File Number: 8-I-26-IH

Meeting: 8/19/2026
Applicant: Jesse Alarcon Onyx Excavation LLC
Owner: Jesse Alarcon Onyx Excavation LLC
District: Oakwood/Lincoln Park Infill Housing Overlay District

Location: 0 Warren Ave. **Parcel ID:** 81 K M 035
Zoning: RN-4 (General Residential Neighborhood)
Description: New primary structure (duplex)

8-I-26-IH
APPLICATION FOR CERTIFICATE OF APPROPRIATENESS

Site Plan
of
Lot 3 - J.C. Whisman Addition
to Knoxville, Tenn.
for
Onyx Excavation LLC

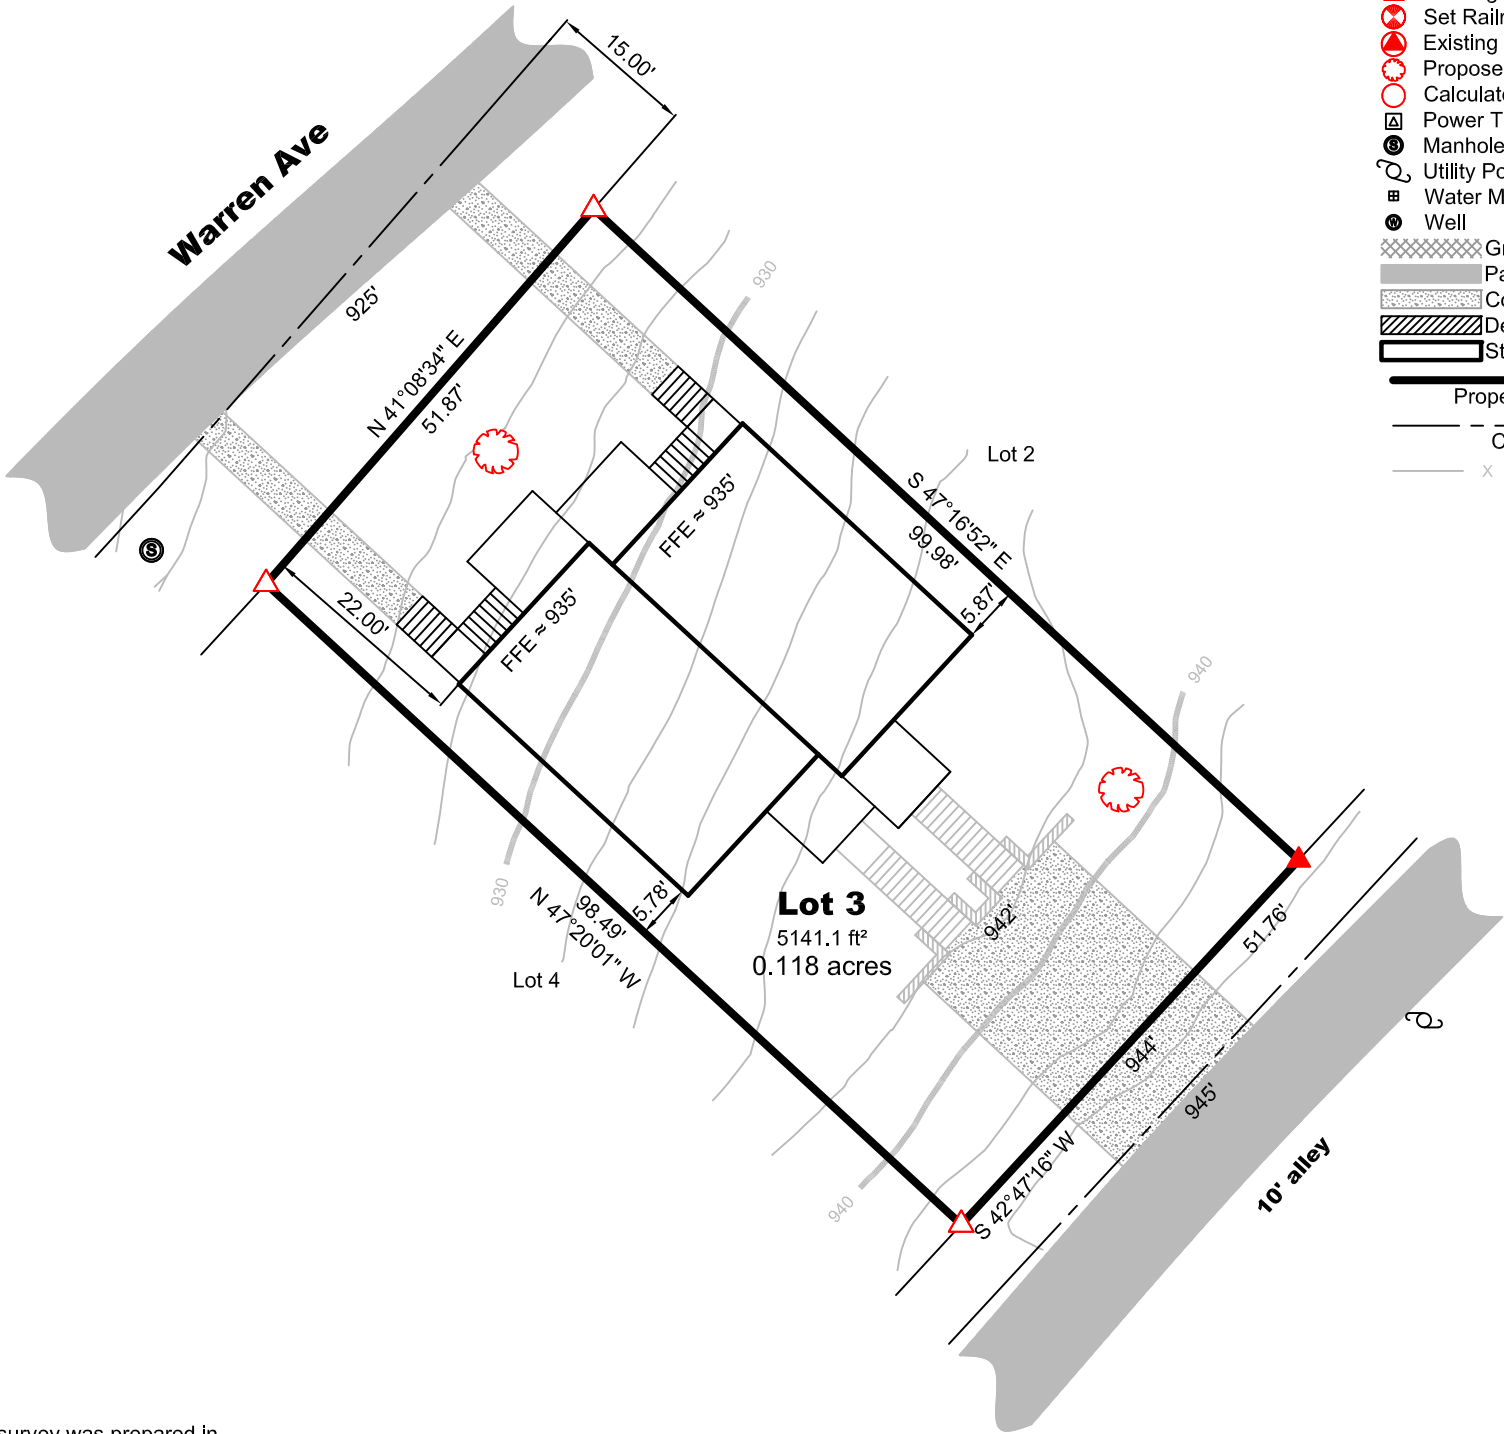
Alleys, Parking, and Services: Alley access is appropriate. The parking pad should be located so as not to harm any existing healthy, mature trees. Revisions to the site plan may be necessary to meet City Engineering standards.

Landscape: Appropriate. Applicant should retain any existing healthy, mature trees in the rear yard. Documentation should be provided to staff if it is not feasible to retain existing, healthy trees in the rear yard, and a new shade tree should be planted.

- 1) the final site plan to meet City Engineering standards, with minor revisions to be approved by staff;
 - 2) meeting applicable standards of Article 4.6 and Article 9.3.J;
 - 3) final elevation drawings to depict the foundation height along the finished grade and dimensions of the projecting windowsills and porch pilasters;
 - 4) major changes to foundation height and porch steps to return to the Board;
 - 5) all porch posts to be the same size, at least 6";
 - 6) the proposed tree in the rear yard to be an existing healthy tree, if viable, with documentation submitted to staff;
 - 7) final guardrail materials to meet Infill Housing design guidelines.
-

UNIT "B"
FRONT ELEVATION

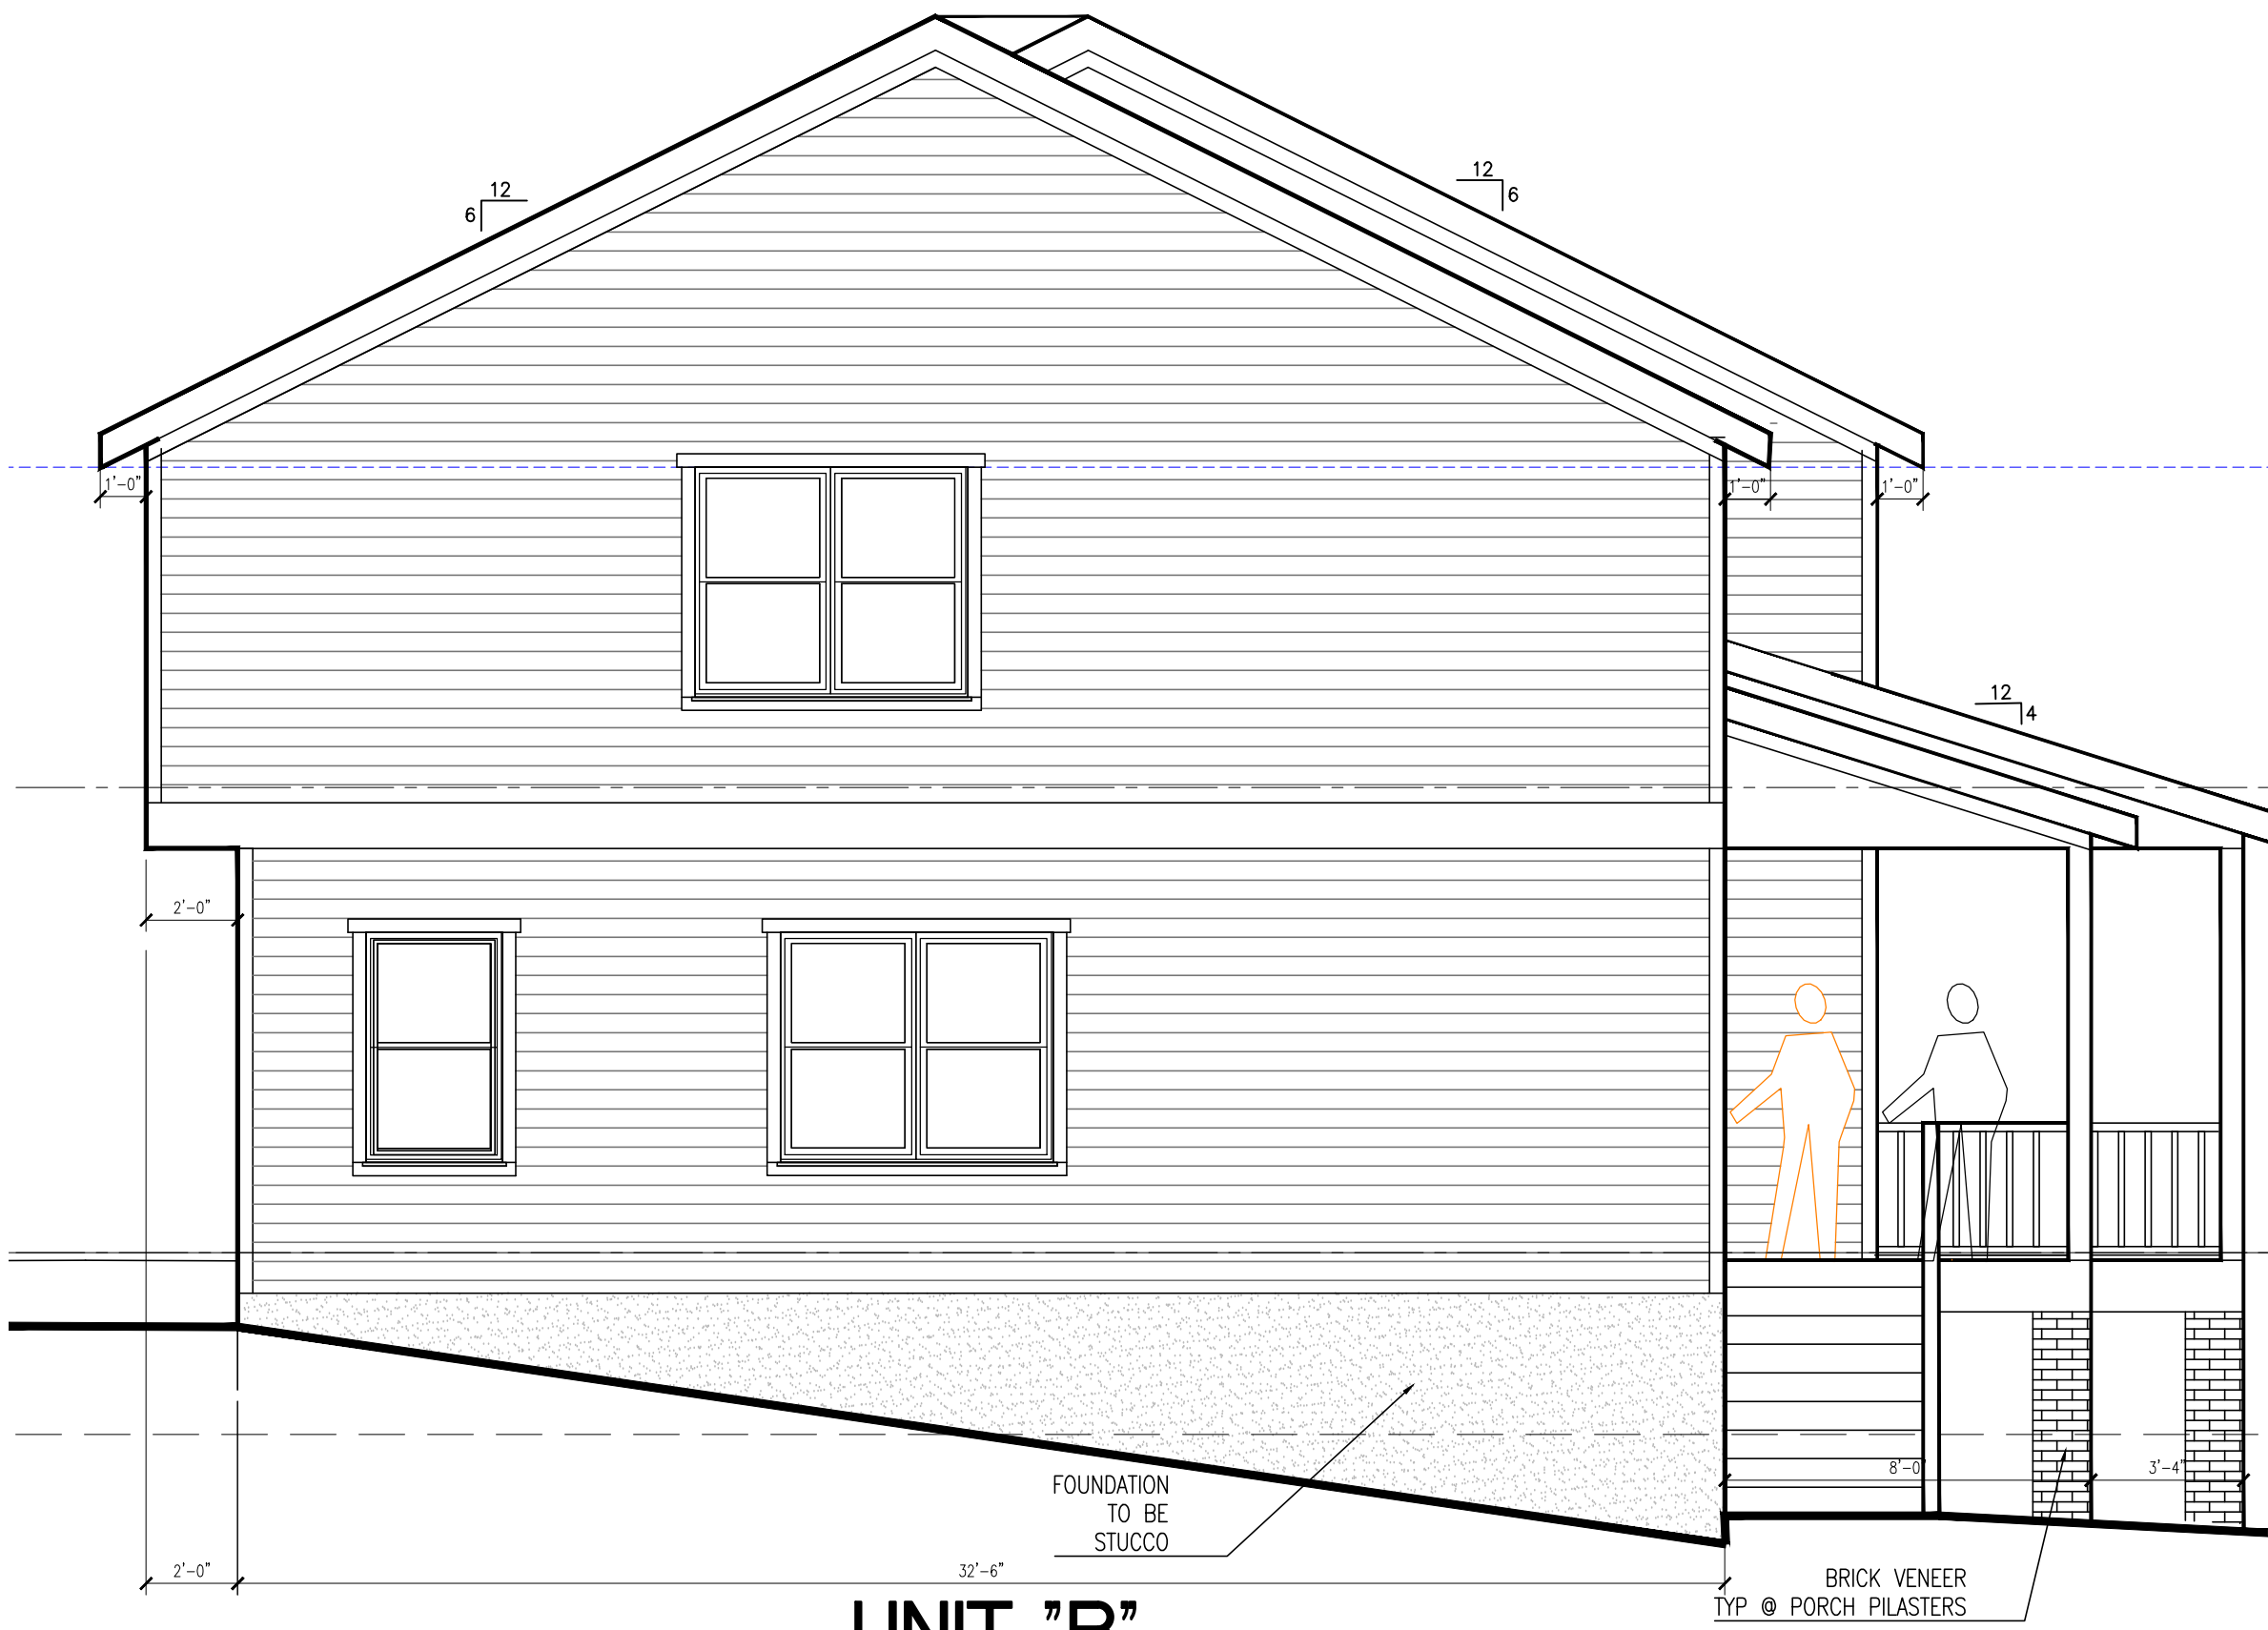
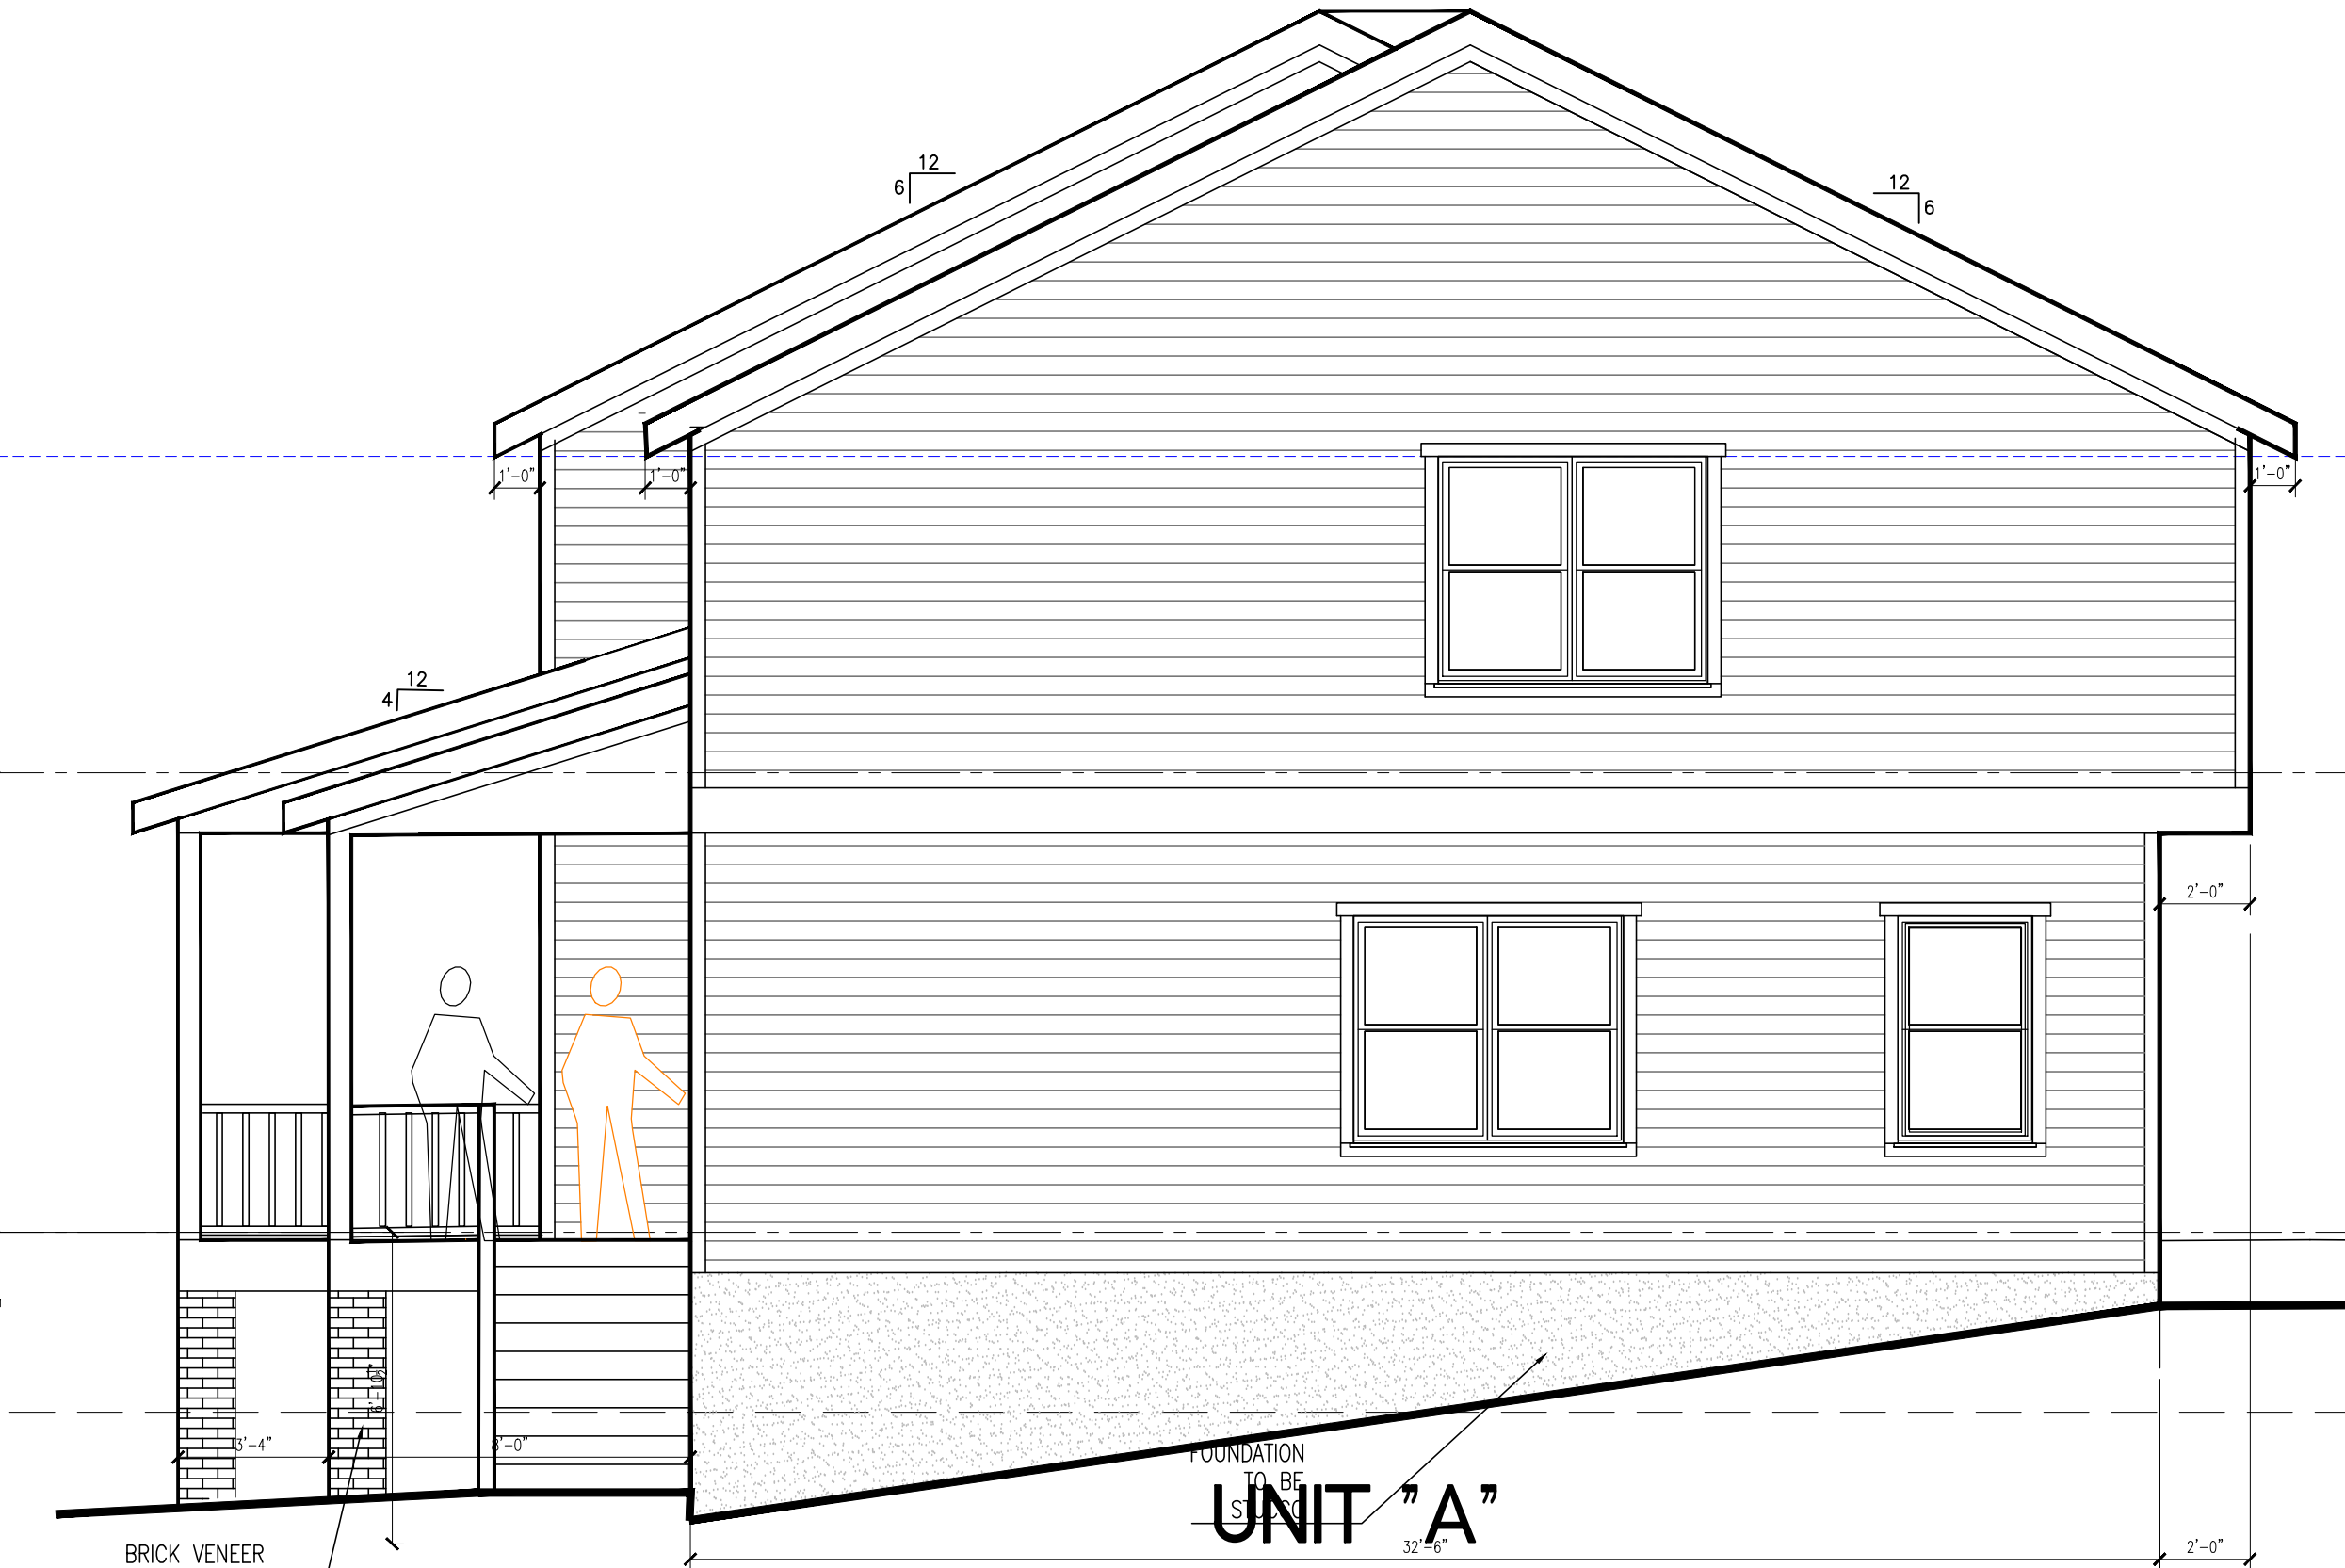
Scale, Mass, and Foundation Height: The proposed scale and height is consistent with the only other house on the blockface. Major changes to the foundation height must return to the Board for review.

Porches and Stoops: The applicant should use posts of the same size and specify guardrail materials, which should not be metal per the design guidelines. The Board should discuss adding a solid wall or screening underneath the front porches.
